GFELLER LINE CONCENTRATORS
49-9-2, 49-11 + 1-2, 49-12-2
AUXILIARY AND APPLIQUE CIRCUITS
DESCRIPTION

1.02 This section is reissued to revise Items C and I and to add Items J, K, and L. These changes cover information for the 49-11+1-2 and 49-12-2 models of the Gfeller line concentrator. The title has been changed accordingly.

Fig. 1

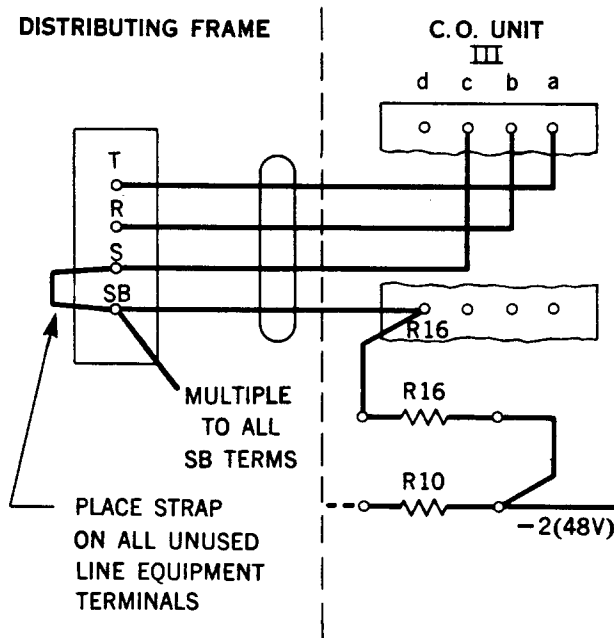
(a) Using the 6-32 bottoming tap, thread the spare hole in the resistor mounting strip below resistor R15.

(b) Mount the new 600-ohm resistor, using the 6-32 screw and washer. Designate the resistor R16 (to conform to the arrangement shown in schematic S10460-4, coordinates d9).

(c) Using a new wire, connect one terminal of the new resistor to the terminal of resistor R10 to which the black-white (battery loop) wire is connected. See Fig. 1.

(d) Using a new wire, connect the other terminal of the new resistor to a spare terminal in the lower half of terminal strip III. Designate this terminal R16.

Fig. 2

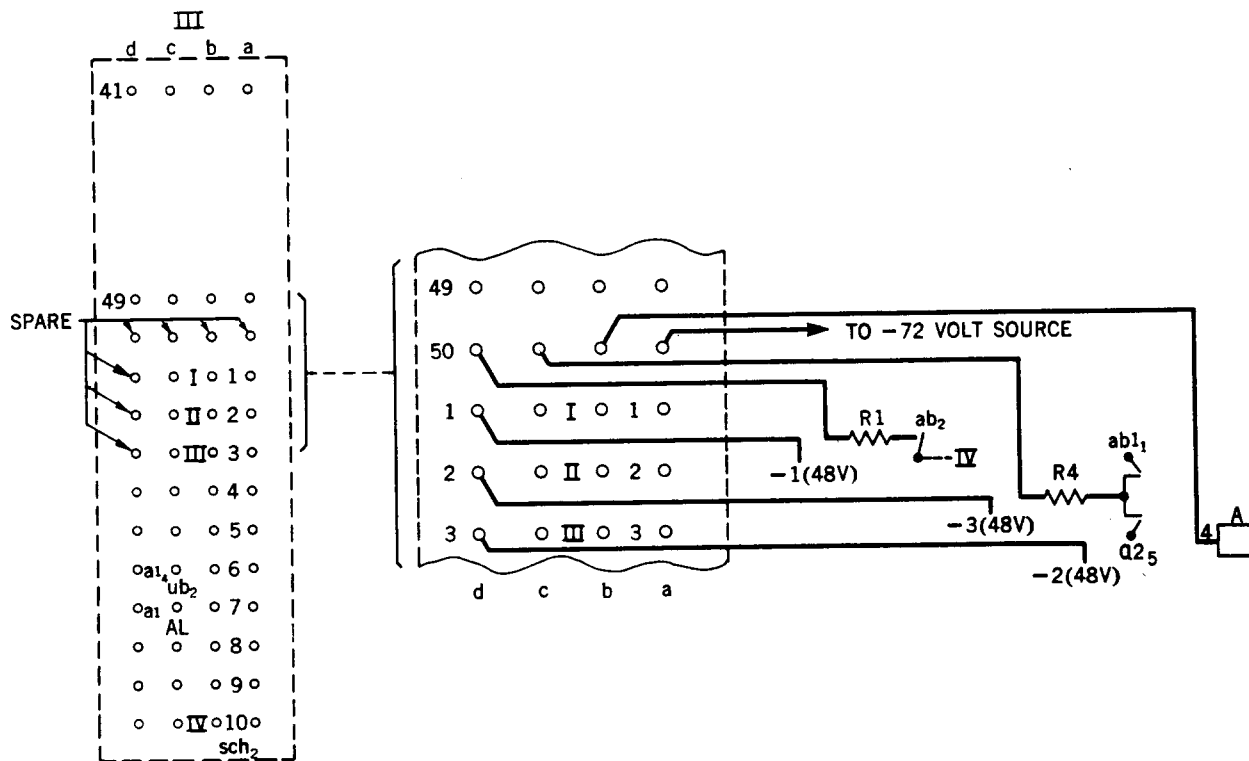
Note: Central office units modified prior to the issuance of Issue 2 of this practice have been wired per Fig. 2 and strapped per Table A. This information has been retained to aid in restrapping units already modified but it is recommended that future units be modified as given below.

Fig. 3

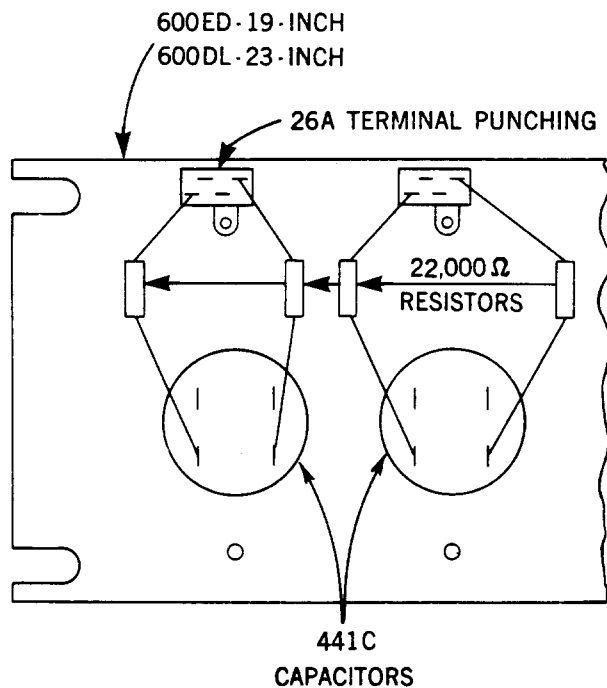
2.13 441C capacitors, 26A terminal punchings and radio-type 22,000-ohm, 1-watt resistors may be assembled on a mounting plate as shown in Fig. 3 and wired as shown in Fig. 4. The applique circuits may be cabled (or wired with paired cross-connection wire through a locally provided ring run) to the line equipment terminal strip on the concentrator or on the distributing frame, to a separate block on the distributing frame and then cross-connected as required, or to the line links.

Fig. 5

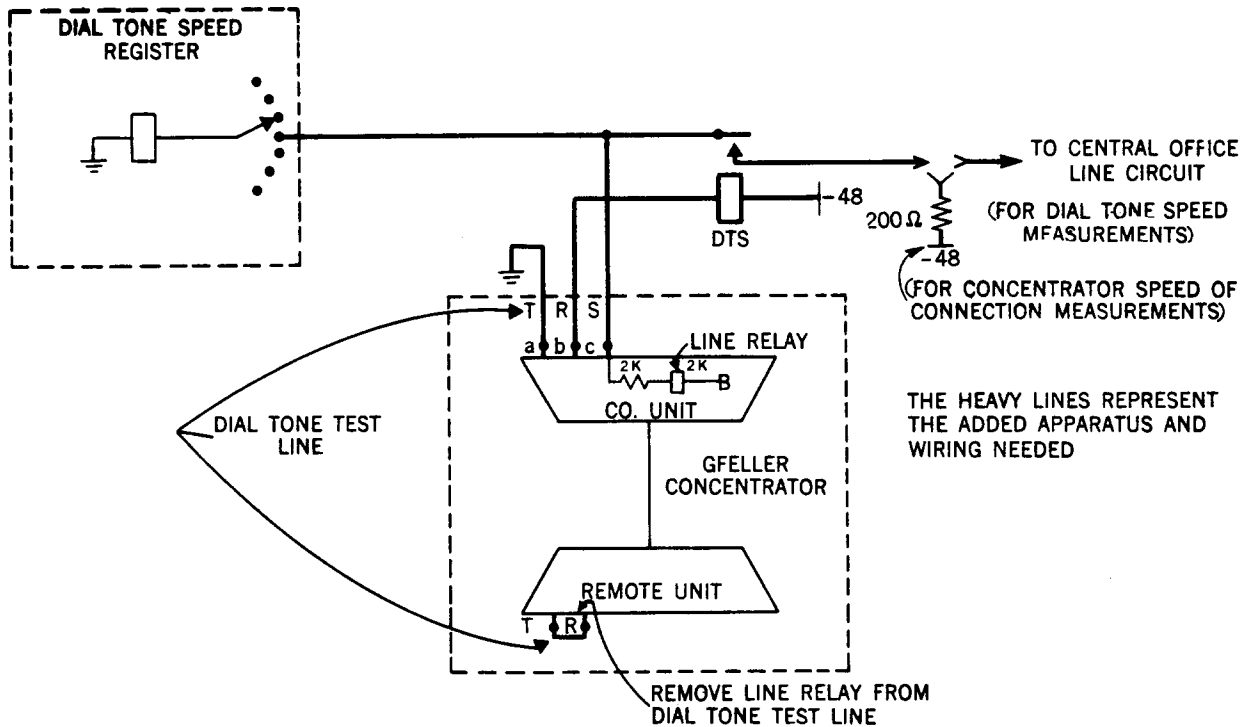
2.14 The circuit shown in Fig. 5 can be used to connect the dial tone speed register circuit to the concentrator. This applique requires:

- (a) Connection to the T, R and S leads of a spare line equipment in the concentrator and to the T or R lead of a spare central office line equipment.
- (b) Disconnection of the corresponding line relay at the remote unit.
- (c) Short circuiting of the T and R of this line at the remote unit.
- (d) Provision of an auxiliary relay (designated DTS in Fig. 5). This relay may be the same type as that used as a line-relay in the particular office and using the same requirements, or a Gfeller type (such as those with the designation BSU, BSG, or SCH) may be used.

Fig. 6

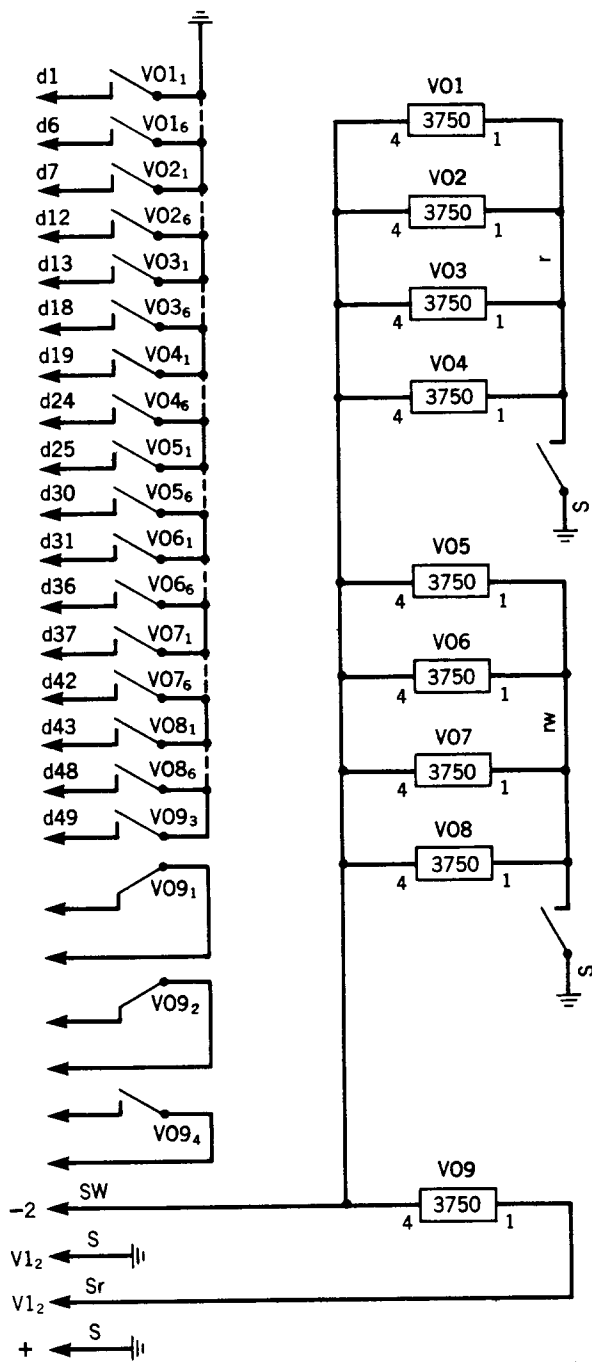
applies a ground to the sleeve of all idle lines when all concentrator trunks are busy, causing a busy signal to be returned on any incoming calls. It is applicable to 49-9-2 concentrators with the serial numbers from 448 up and to all 49-12-2 concentrators. A schematic of the circuit is shown in Fig. 6.

- (a) Battery feed loop (lead from winding terminal 4, VO9 relay) to -2 terminal.
- (b) Ground lead (wire designated + on Fig. 6) to + terminal.
- (c) The lead (wire designated V1₂ on Fig. 6) from number 1 winding terminal of the VO9 relay to one of the V1₂ terminals.
- (d) Connect the other V1₂ terminal to + terminal (ground).
